RE: **APPROVAL** of 1000, 1250, and 1500 gallon Two Compartment Polyethylene Septic Tanks for use in Wyoming.

1000 GALLON SEPTIC TANK

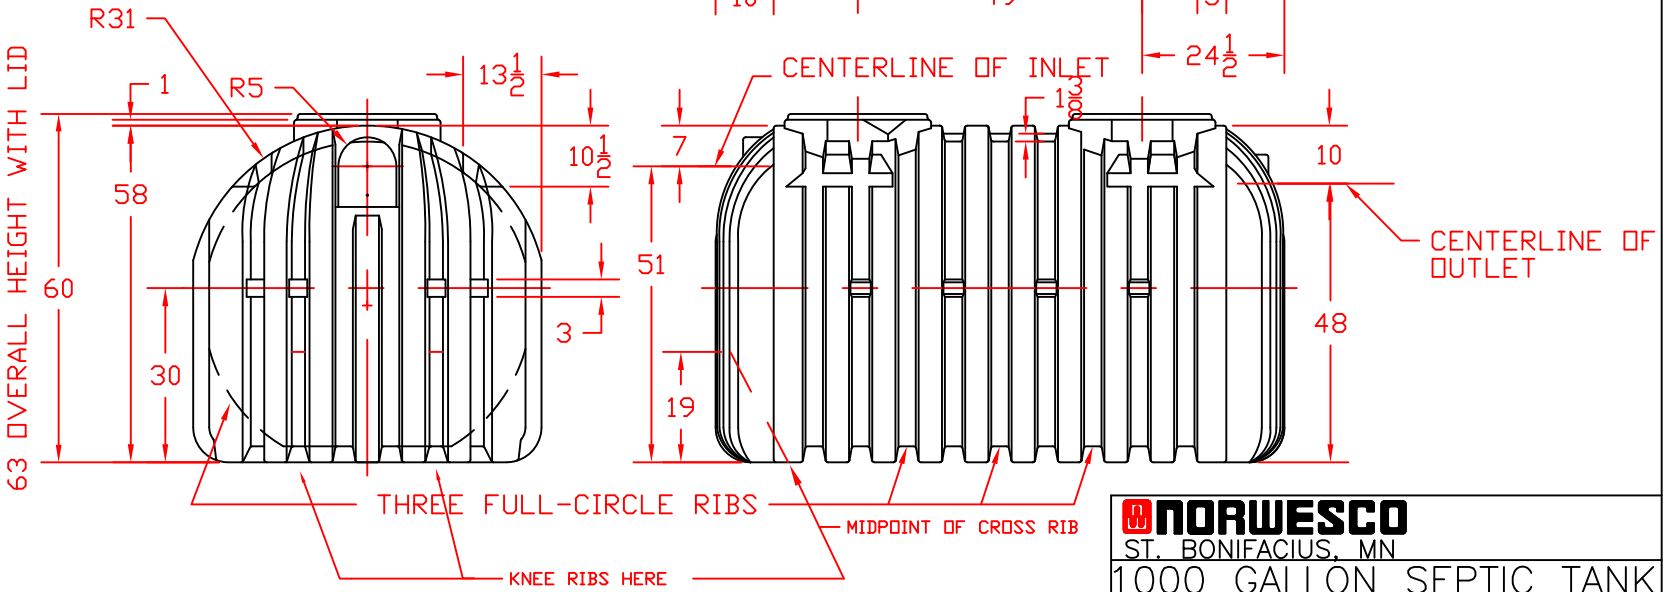
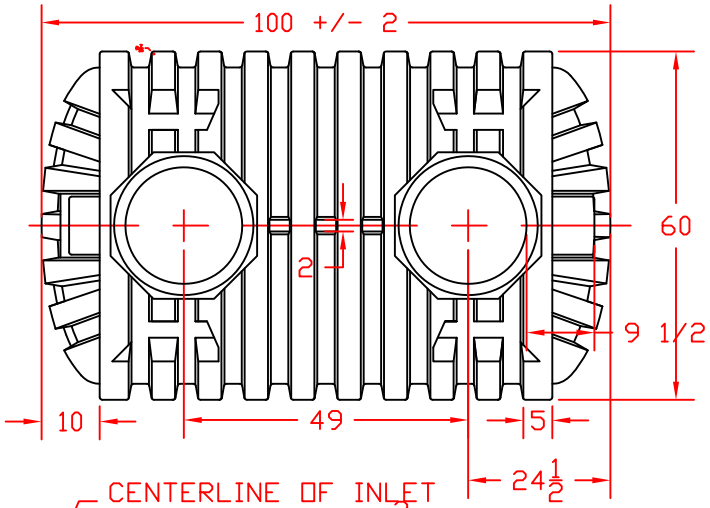
The Water Quality Division (WQD) of the Wyoming Department of Environmental Quality (DEQ) has received and reviewed the specifications for your 1000, 1250, and 1500 gallon two compartment polyethylene septic tanks. The WQD finds that these septic tank designs meet the minimum requirements as identified in Chapter 11, Section 39 of the Water Quality Rules and Regulations, except for one condition which must be imposed. Subsequently, these products will be placed on our list of approved septic tanks for use in Wyoming with the following condition:

> "The manways on the septic tanks (one on each compartment) must be extended to the ground surface because there are no clean-outs provided on the Norwesco septic tanks."
